Stage 3: Workgroup Report	At what stage is this document in the process?
<h1>GC0096</h1> <h2>Modification Title: Energy Storage</h2>	<div>01 Proposal Form</div> <div>02 Workgroup Consultation</div> <div>03 Workgroup Report</div> <div>04 Code Administrator Consultation</div> <div>05 Draft Grid Code Modification Report</div> <div>06 Final Grid Code Modification Report</div>
<p>Purpose of Modification: This proposal seeks to modify the Grid Code to define the appropriate technical requirements for Storage technologies connecting to the Transmission System and associated changes to the Grid Code requirements for making a connection.</p>	
	<p>This document contains the discussion of the Workgroup which formed in January 2017 to develop and assess the proposal, the responses to the Workgroup Consultation which closed on 11 January 2019, the voting of the Workgroup held on 13 Month 2019 and the Workgroup's final conclusions.</p>

This document is the Workgroup Report that contains the discussion of the Workgroup which formed in January 2017 to develop and assess the proposal, the responses to the Workgroup Consultation which closed on 11 January 2019 and the voting of the Workgroup held o

Figure 2.0

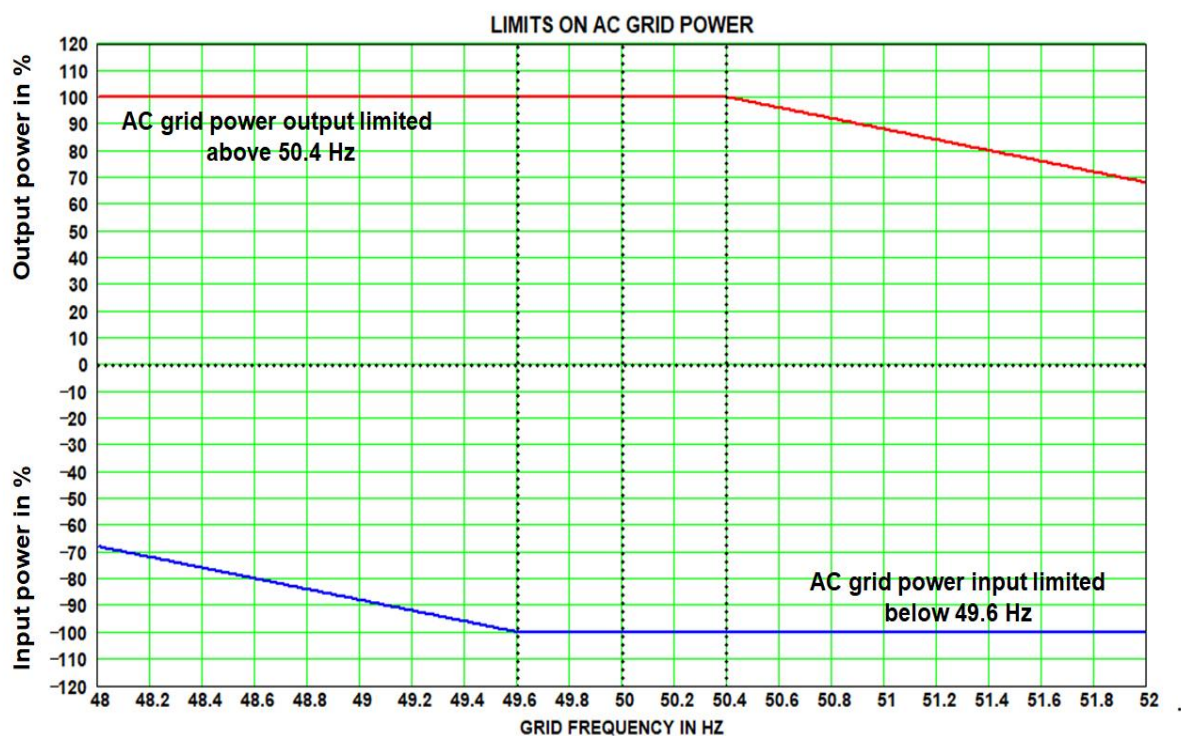
As part of the Workgroup discussions, one Workgroup member noted that storage should have a requirement to cater for limiting power input with falling frequency and limiting power output with rising frequency and proposed the use of the following graph.

The Proposer would however note that the characteristic shown in Figure 2.0 may be more appropriate however as also pointed out by a workgroup member this requirement applies to generation equally as it applies to Storage. As such, and as the aim of the workgroup is to ensure consistent treatment between different classes of User's, this is an issue that should be highlighted as a future area of work as the implications of a change to generation affects a much greater audience.

Figure 3.0 (a)

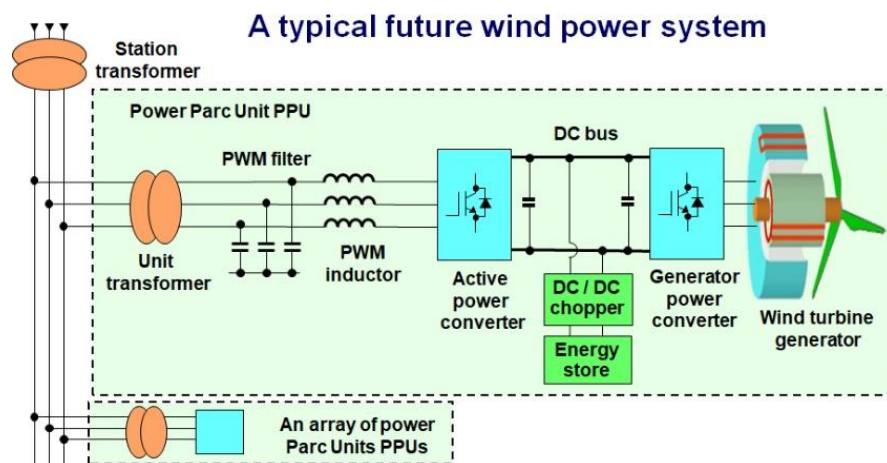
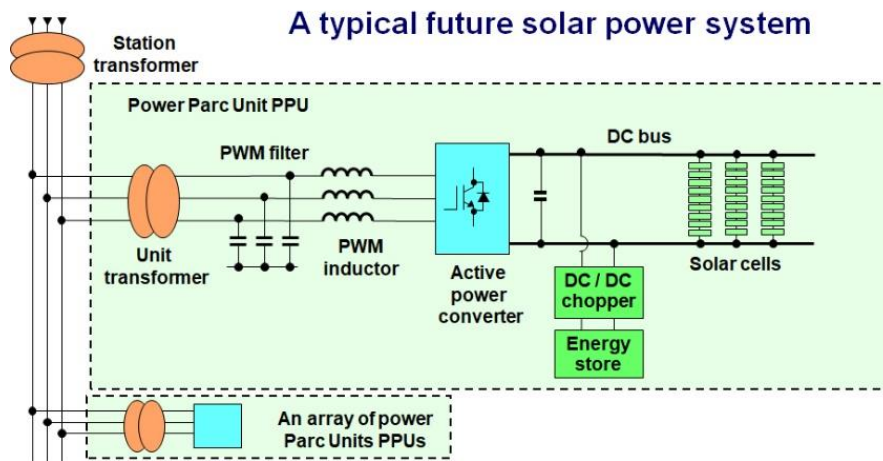
In addition, a Workgroup Member noted that as part of a future co-located site that it was entirely likely that an energy storage technology could be integrated as part of a solar park, wind farm or synchronous plant. Figure 3.0(a) and Figure 3.0(b) below (which have been re-produced in this report with the kind permission of ENTSO-E) illustrate this example for a wind farm or solar park.

One Workgroup member noted that for wind farms and solar parks, the storage elements are not directly connected to the AC system and raised concern that they would not be required to satisfy the requirements of the GC0096 proposals. It was also noted that for rotating synchronous generators this is not so much of an issue.

In response, the Proposer would note that where you have a Power Station comprising of Power Park Modules and/or Electricity Storage Modules, the Grid Code applies to the Power Park Modules and Electricity Storage Modules within that Power Station.

In addition, the Proposer would note that as part of the GC0096 proposals, that when a storage element is operating in a condition analogous to demand, then there is a requirement for this demand to be reduced as frequency falls as defined under OC6.6, in just the same way as pump tripping as part of a pumped storage plant.
